**CITY OF WEST DES MOINES
PLAN AND ZONING COMMISSION COMMUNICATION**

Item: Fareway Plat 1, Southwest corner of S. 81st Street and Mills Civic Parkway –
Subdivide property into 1 lot for commercial development –
Fareway Stores, Inc. – PP-003464-2017

Requested Action: Approval of Preliminary Plat

PRELIMINARY PLAT

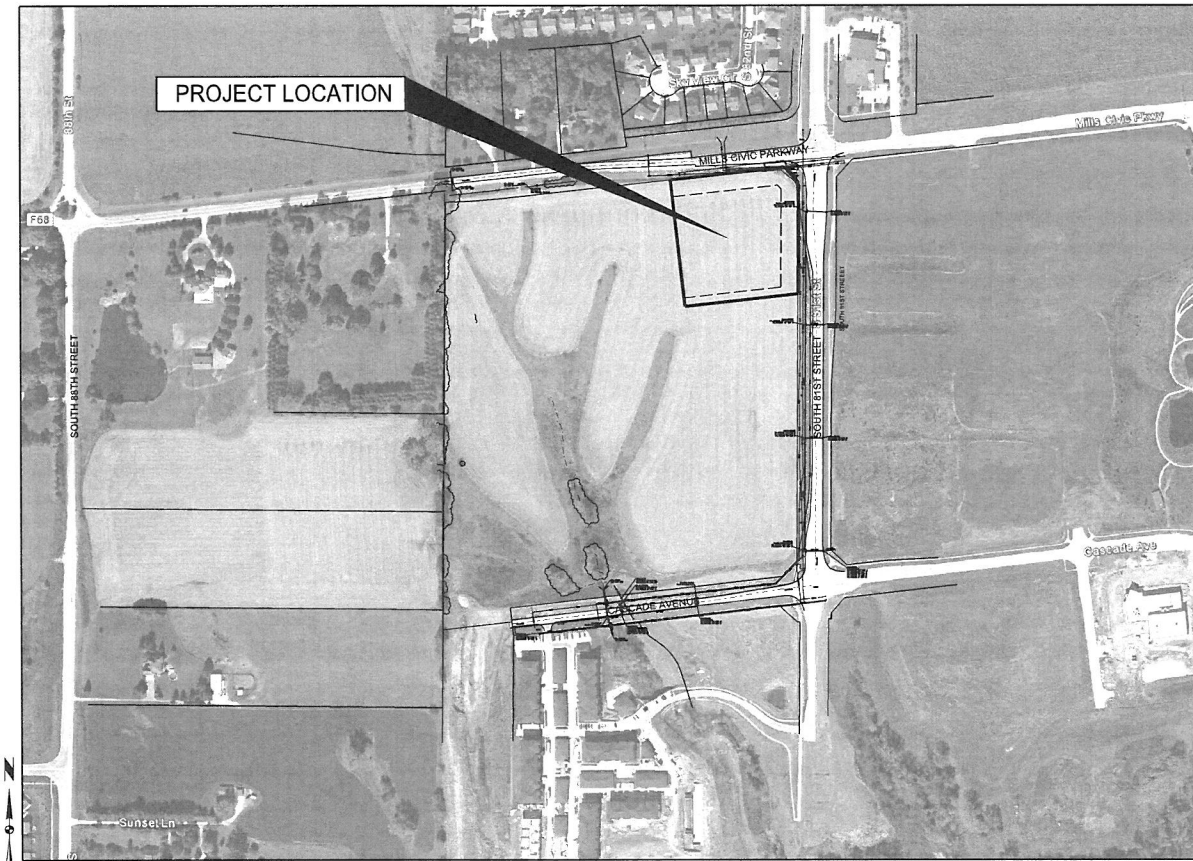
- **Site Plan:** The Fareway site plan shown on the preliminary plat has not been reviewed in detail by staff. The applicant elected not to submit the full site plan for review at this time. The site plan will be reviewed at a future date and brought forward to the Plan & Zoning Commission and City Council for consideration.

- **Access:** Access to the property from Mills Civic Parkway will be via a shared (with the property to the west, owned by Robert F. Etzel Living Trust) full access drive that will be located on the Etzel property. An ingress/egress easement between Fareway and Etzel will be executed and recorded with the Fareway Plat 1 Final Plat to provide for this access. There will also be a full access drive connecting to S. 81st Street.

- **Sanitary Sewer:** A public sanitary sewer main will be constructed to serve the Fareway site from an existing sanitary sewer main located on the south side of the Etzel property. Fareway and Etzel have a private agreement for the extension of this sewer main.

1. An ingress/egress easement for access to the site from the property to the west shall be submitted and recorded at the time of associated final plat approval.
2. The site plan shown on the preliminary plat is not approved with the preliminary plat. City Council approval of the associated Fareway site plan shall occur prior to any construction (private utilities, parking lots, or building construction) occurring on the site.
3. The applicant receiving City Council approval of the associated Final Plat prior to issuance of any building permit, including footing and foundation permits for the lot.
4. Public improvements on the site shall be accepted by the City or surety provided for their completion prior to the approval and release for recordation of the associated Final Plat.
